SUNDRY NOTICES AND REPORTS ON WELLS
Do not use this form for proposals to drill or to re-enter an abandoned well. Use form 3160-3 (APD) for such proposals.

8. Well Name and No.
ELLIOTT GAS COM T 1

PLUG AND ABANDONMENT PROCEDURE

CONDITIONS OF APPROVAL

Proposed Wellbore Diagram

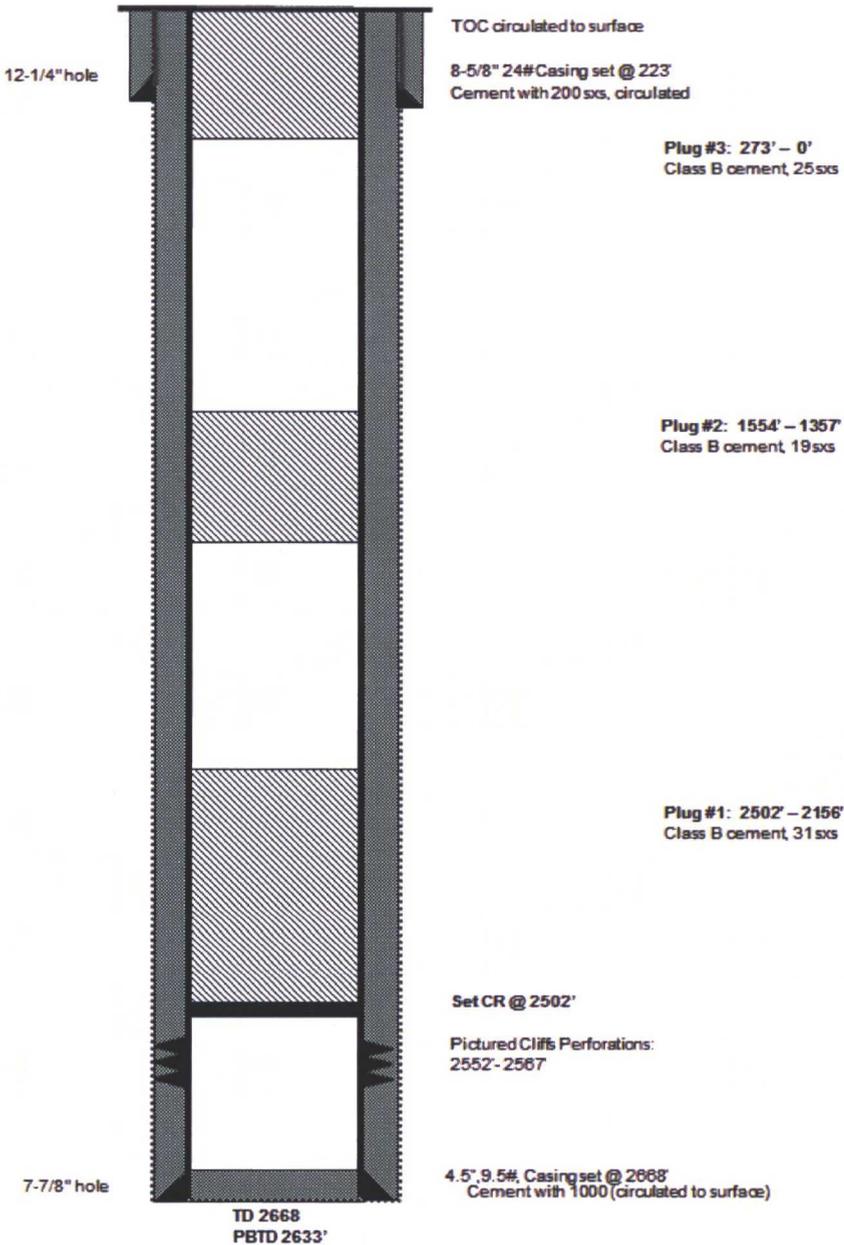
1. Plugging operations authorized are subject to the attached "General Requirements for Permanent Abandonment of Wells on Federal and Indian Lease."
2. Farmington Office is to be notified at least 24 hours before the plugging operations commence (505) 564-7750.
3. The following modifications to your plugging program are to be made:
 - a) Set Plug #2 (1580-1308) ft. to cover the entire Ojo Alamo interval. BLM picks top of Kirtland at 1530 ft. BLM picks top of Ojo Alamo at 1358 ft.

Operator must run a CBL to verify cement top. Submit the electronic copy of the log for verification to the following addresses: jwsavage@blm.gov Brandon.Powell@state.nm.us

You are also required to place cement excesses per 4.2 and 4.4 of the attached General Requirements.
